MDS Building – 5th Floor Renovation

ADDENDUM #3

#### **Addendum Number Three**

### **SHA.UKY2205**

PLAN DETAIL 1" = 1'-0"

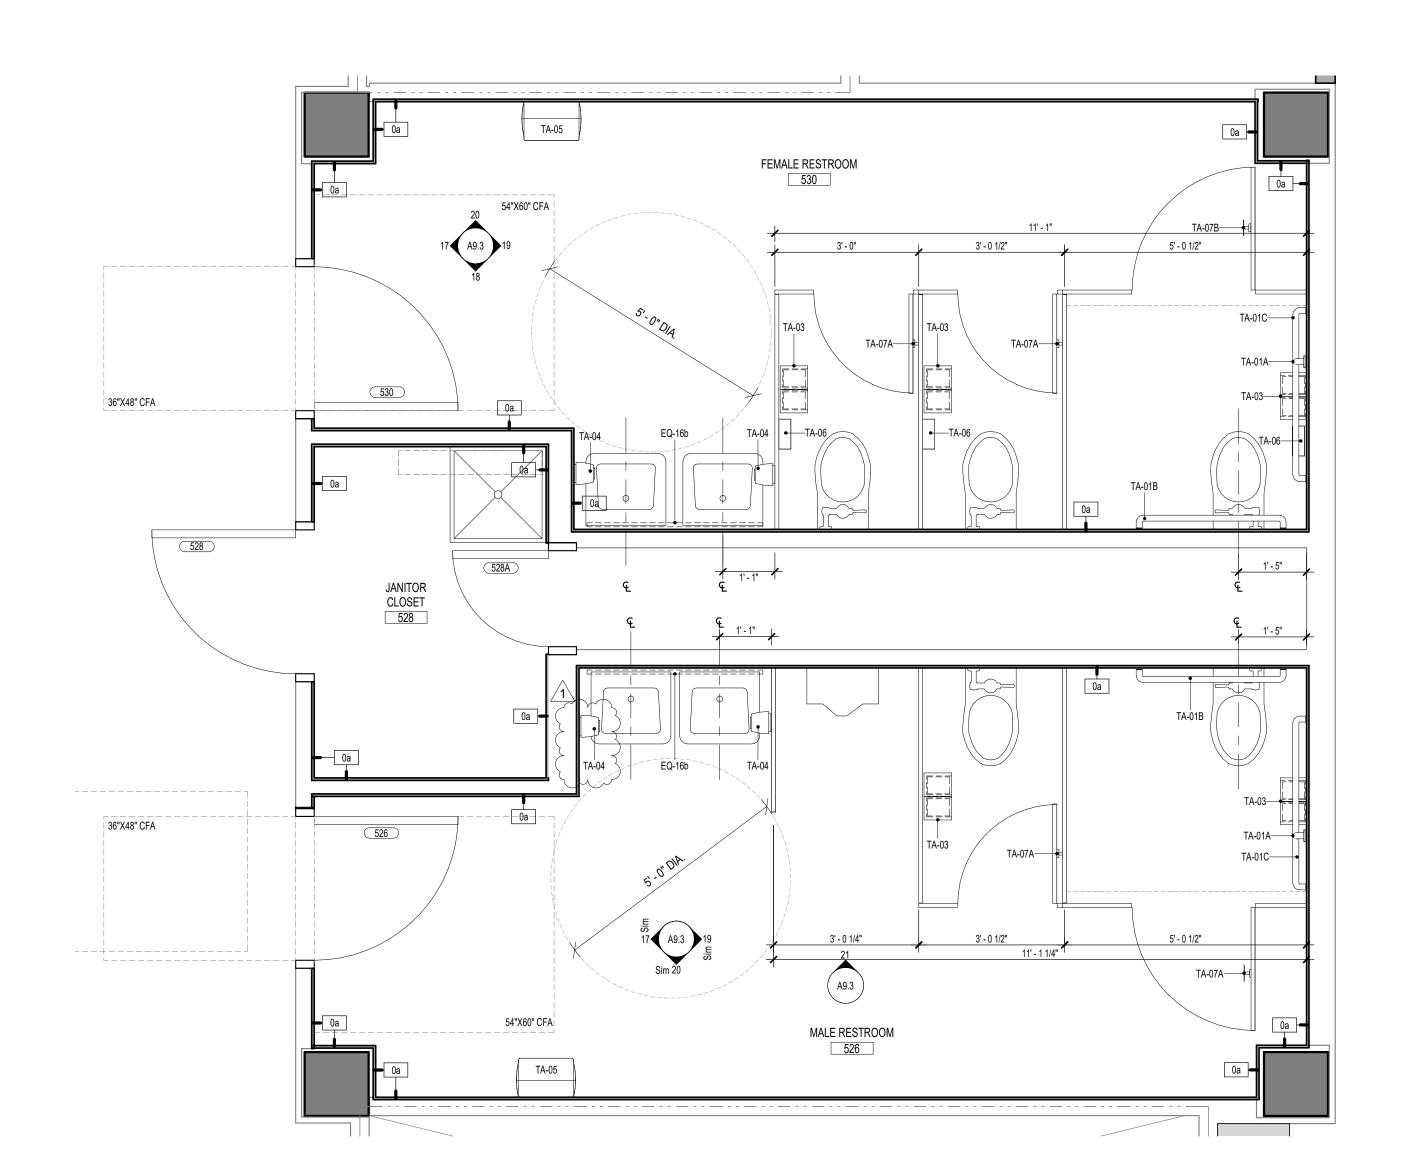
**A. Clarification:** Added sheet A4.5 Enlarged Plan Details to the drawings set (related to the

ENLARGED FIFTH FLOOR CEILING PLAN

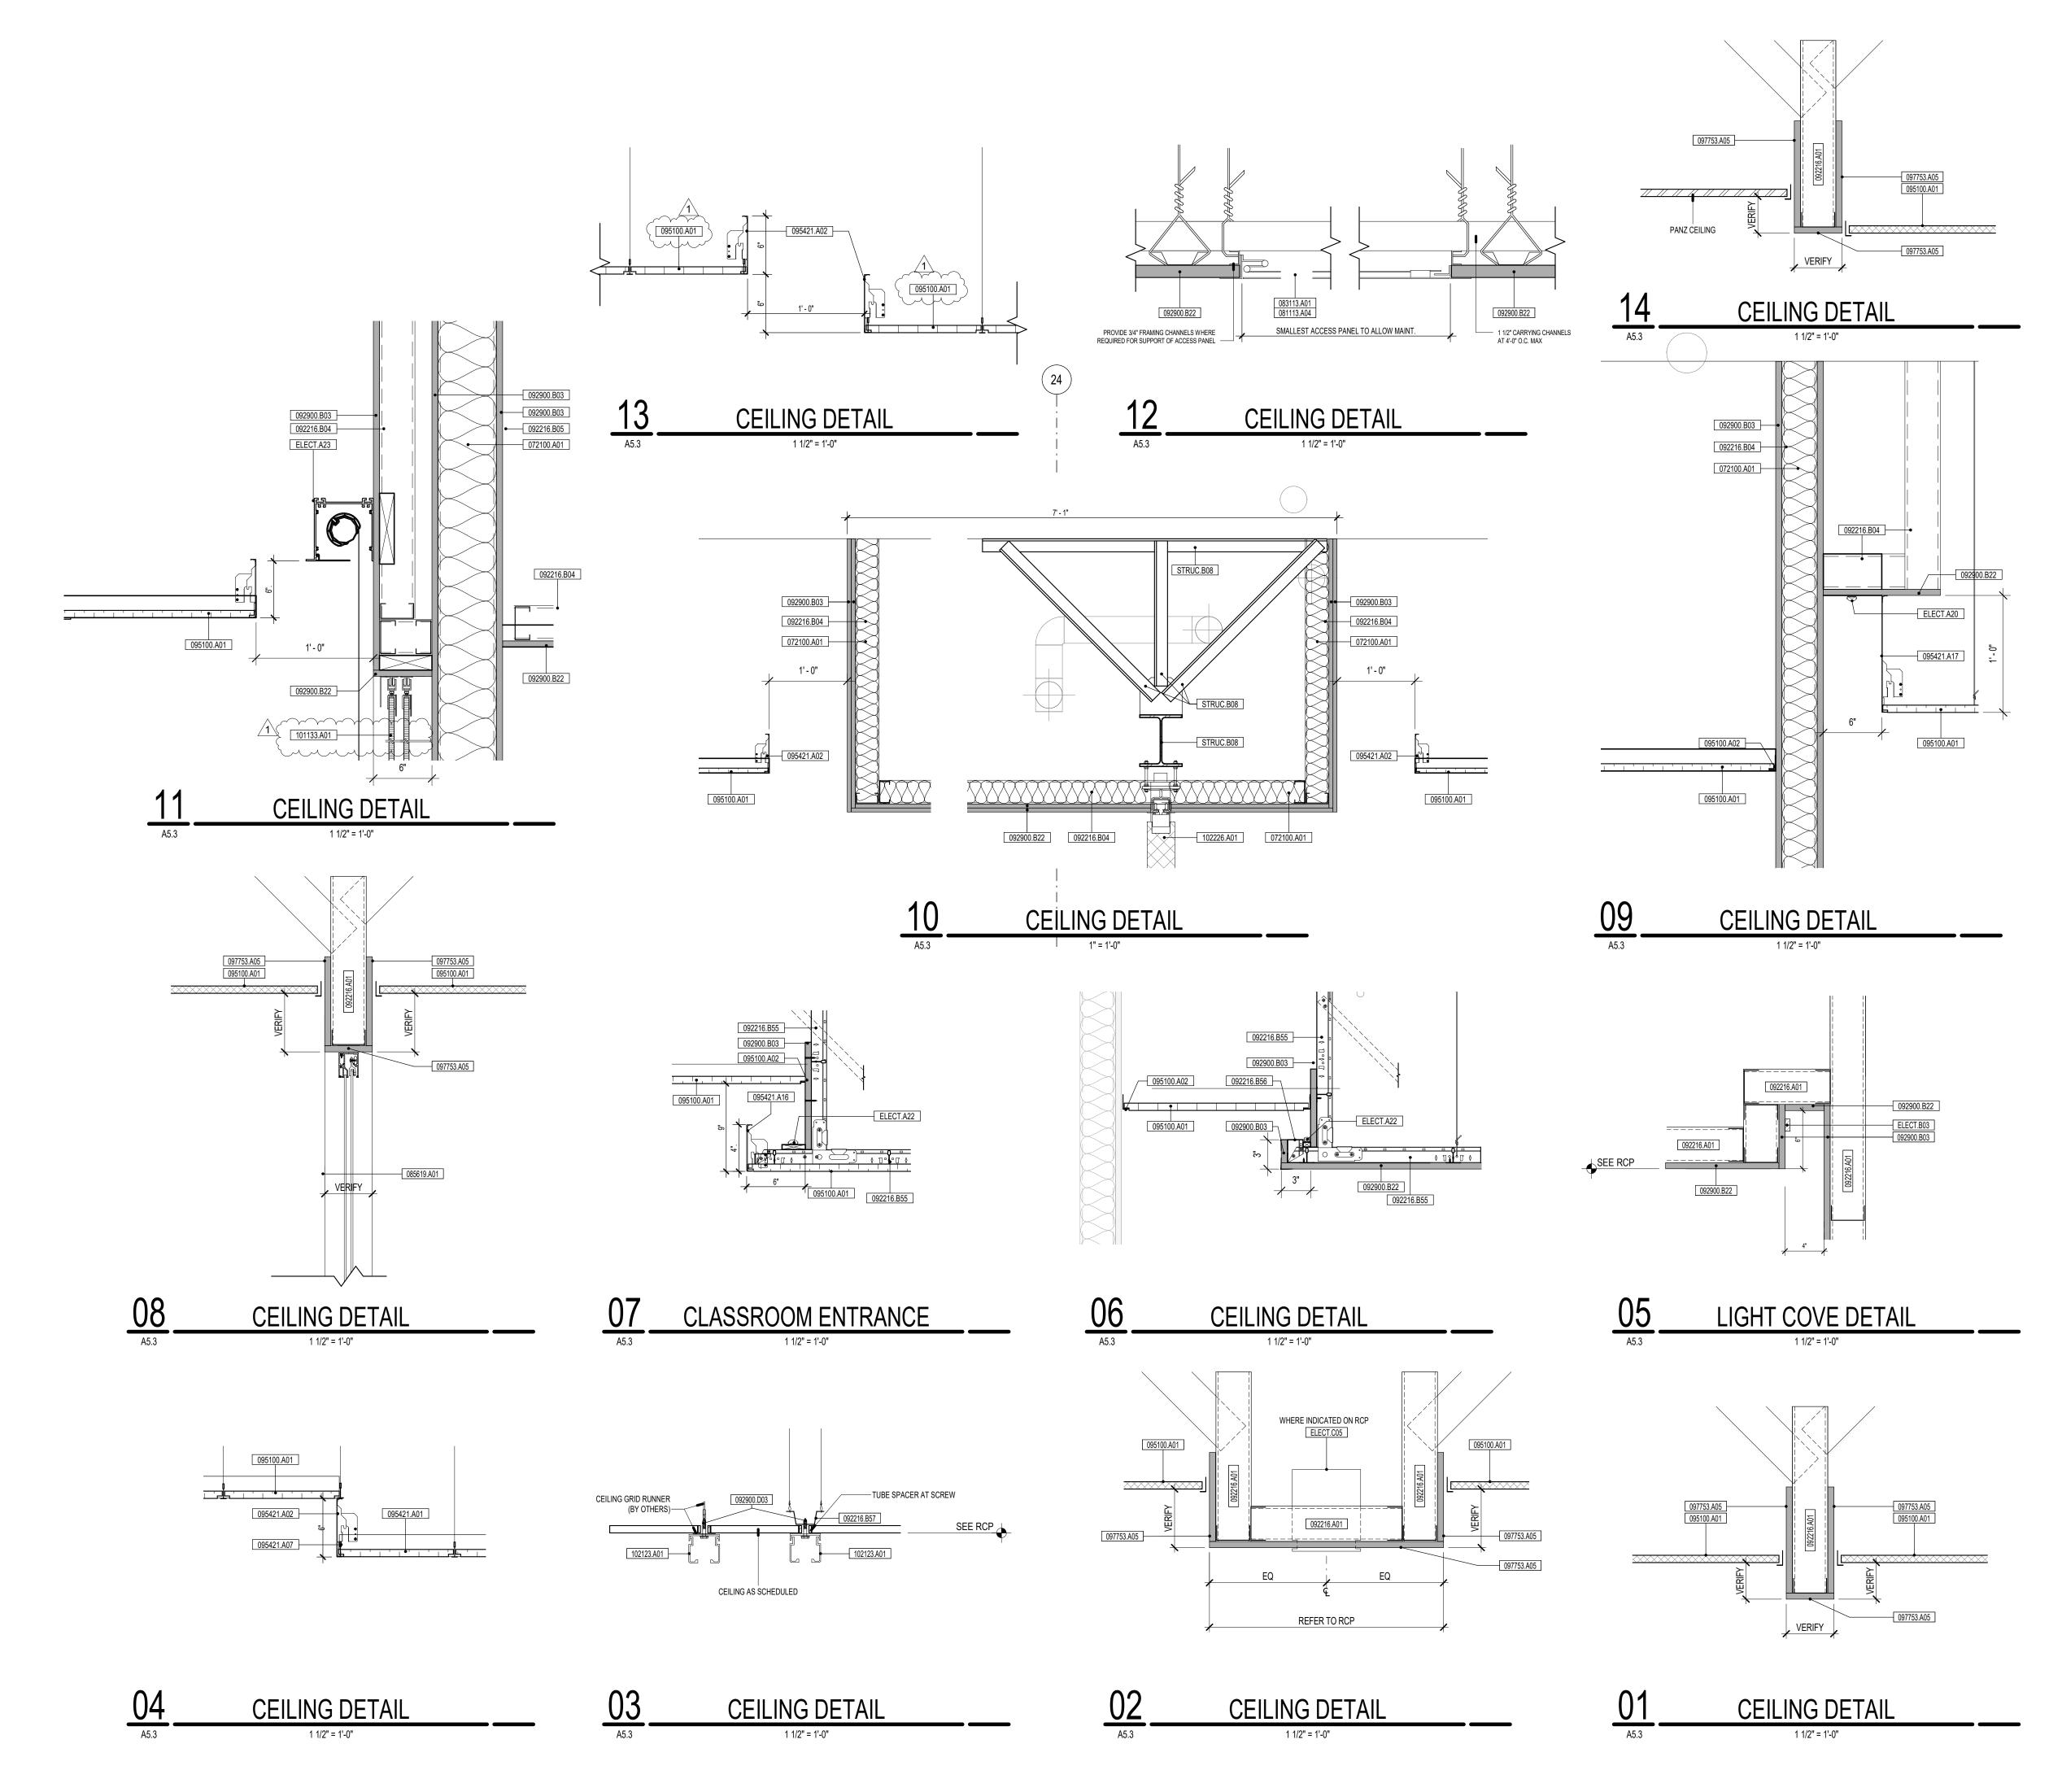
**A. Clarification:** Added ceiling height tags – Corridor 500A.

**B. Clarification:** Revised ceiling to align with wall revision of Fire Department Valve

C. Clarification: Added Ceiling Keynote to rooms 501 & 501D

FIFTH FLOOR - PLUMBING - NEW WORK

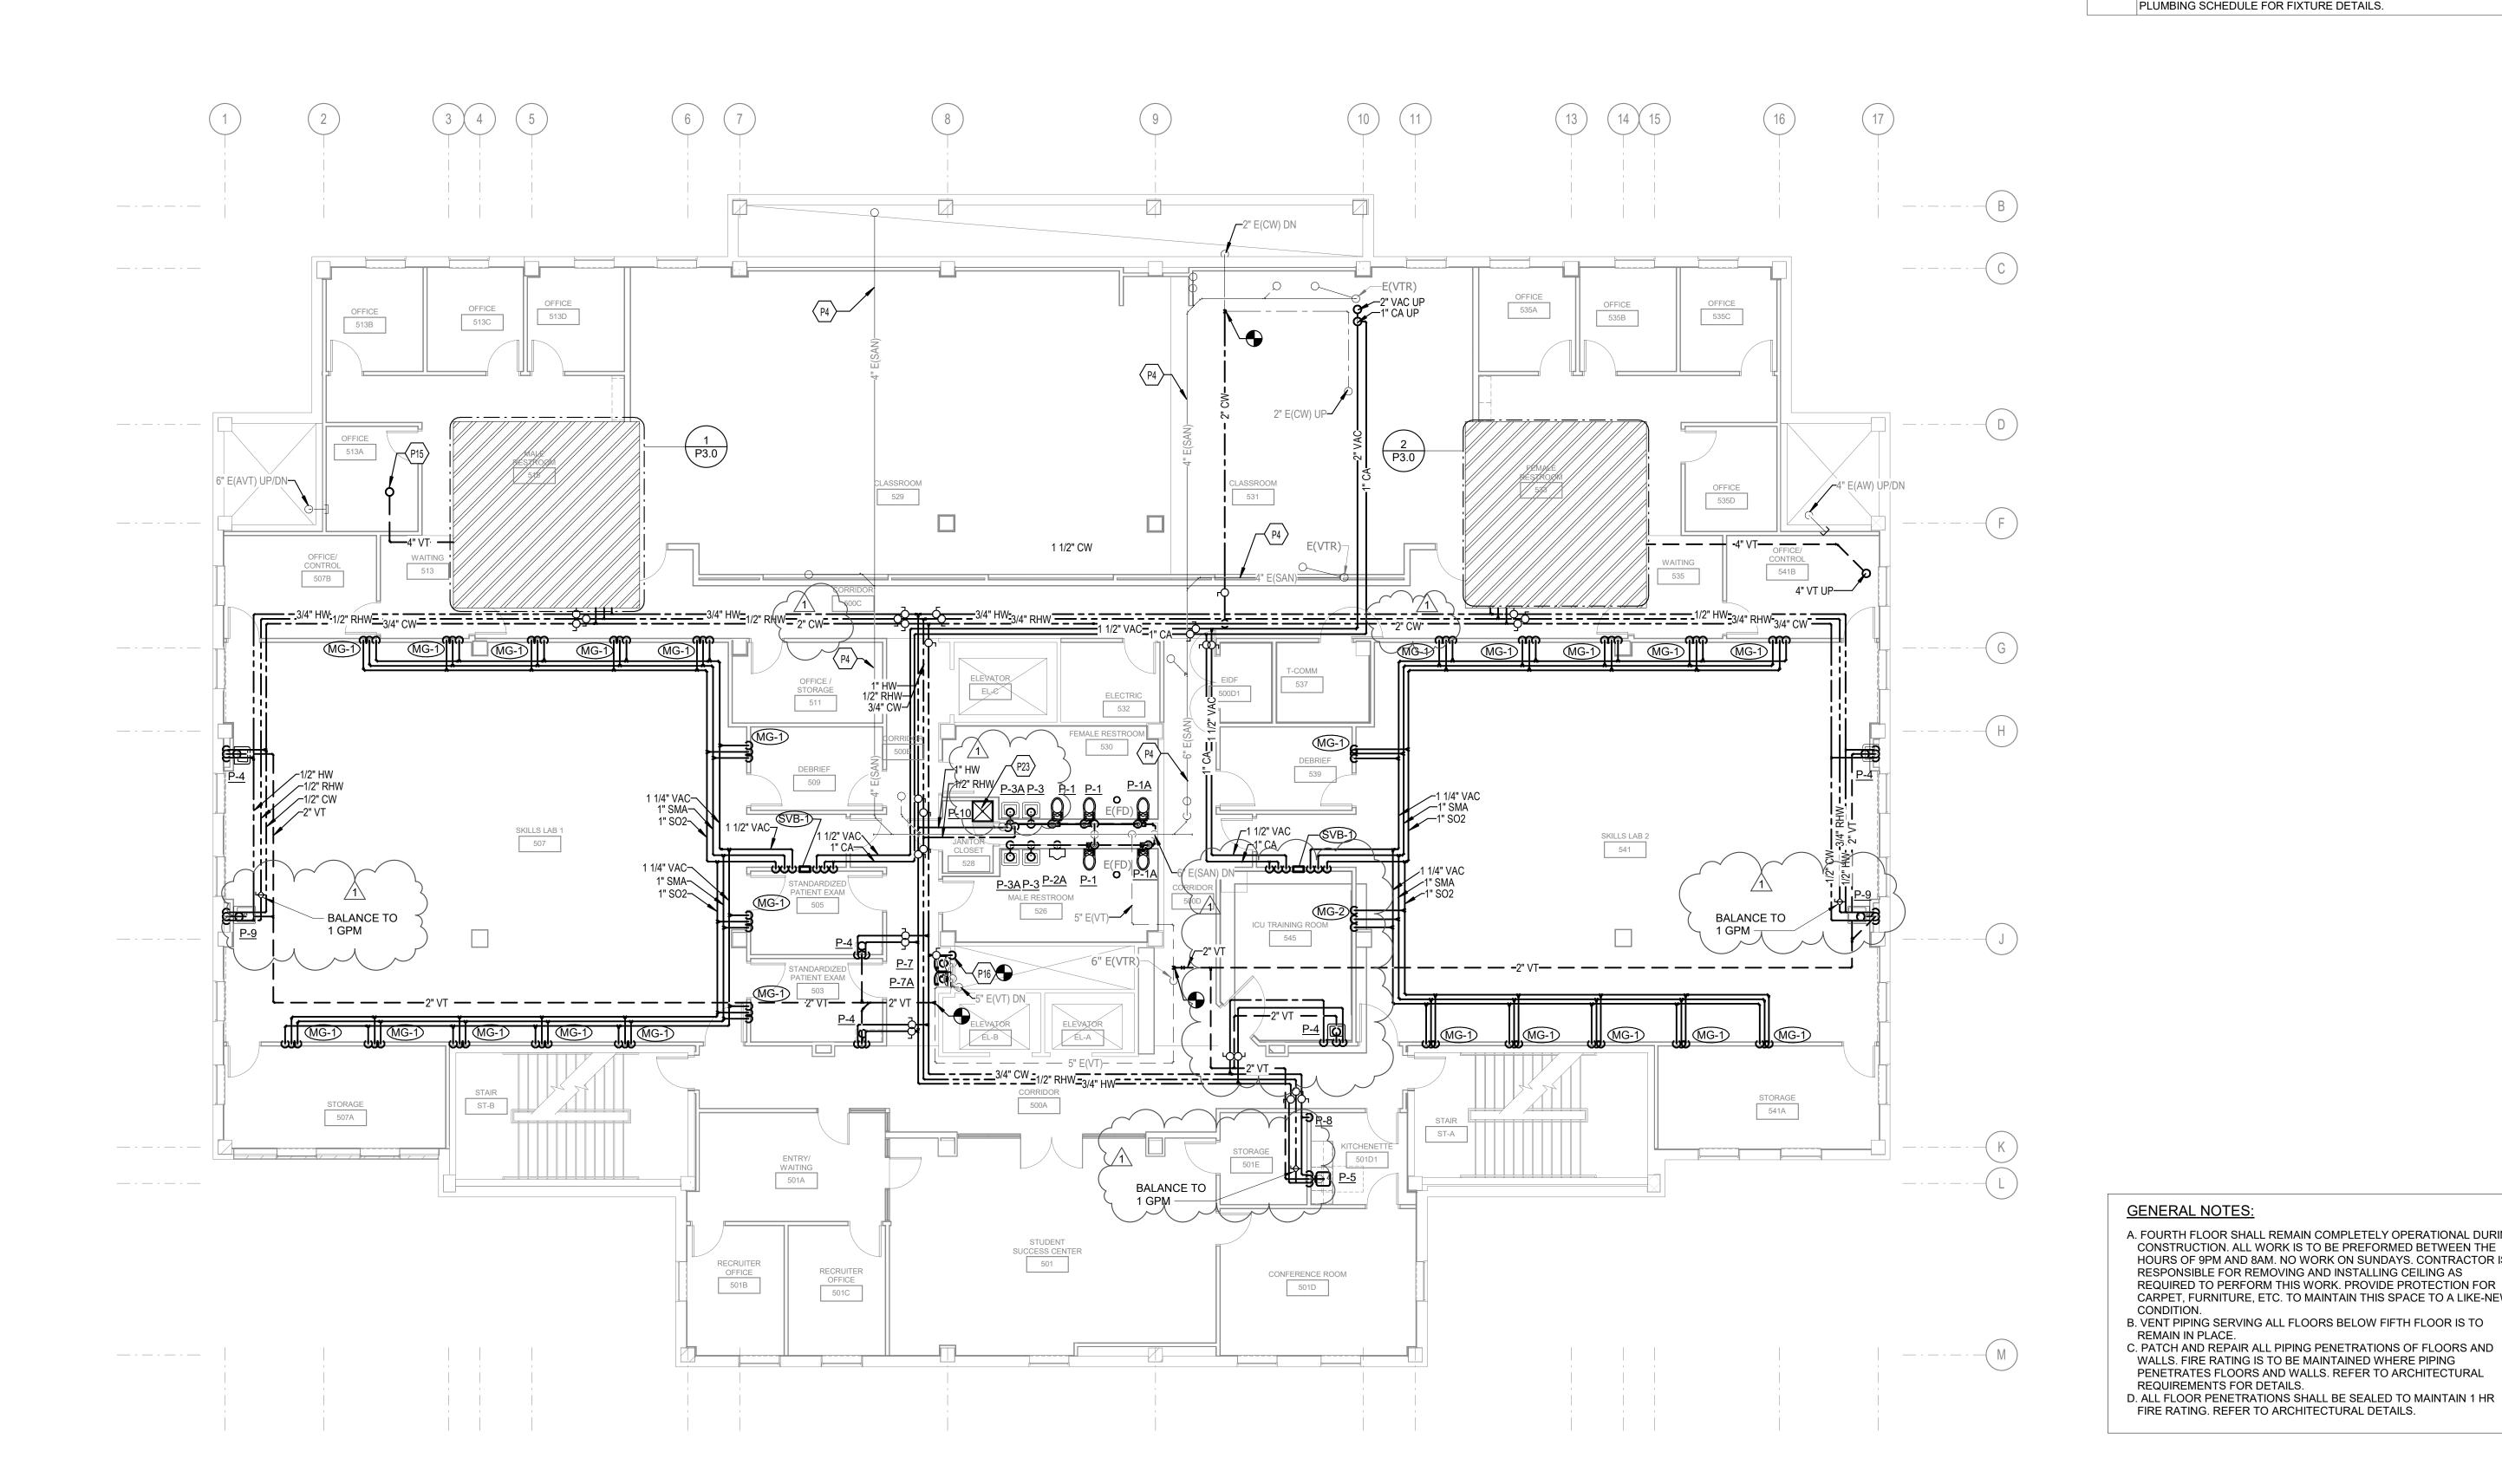
**A. Clarification:** Revised sanitary piping below ICU Training – 545 room.

**A. Clarification:** Revised ICU Training – 545 room. Deleted (1) P-4 fixture.

**B. Clarification:** Added MG-2 to ICU Training – 545 room.

MEDICAL AIR COMPRESSOR DETAIL SCALE: NONE

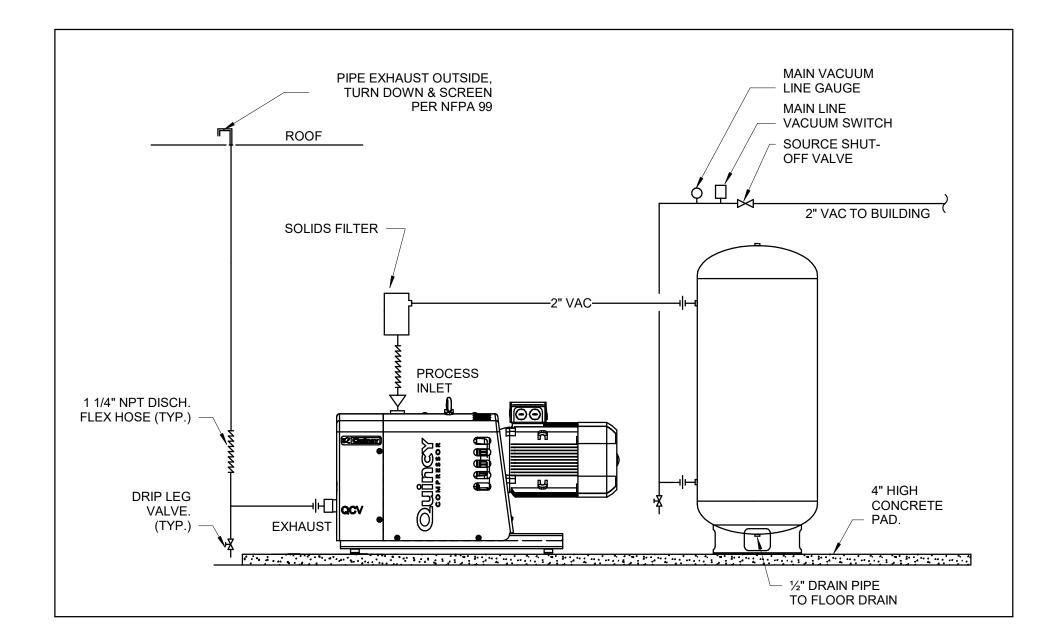
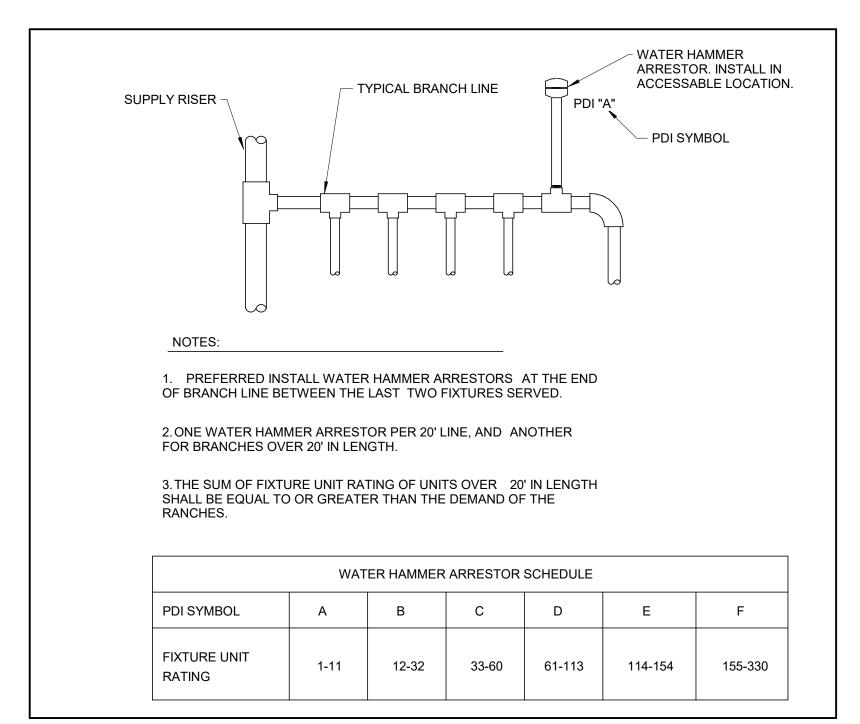
**B. Clarification:** Revised Medical Air Compressor Detail to indicate Type L copper piping to
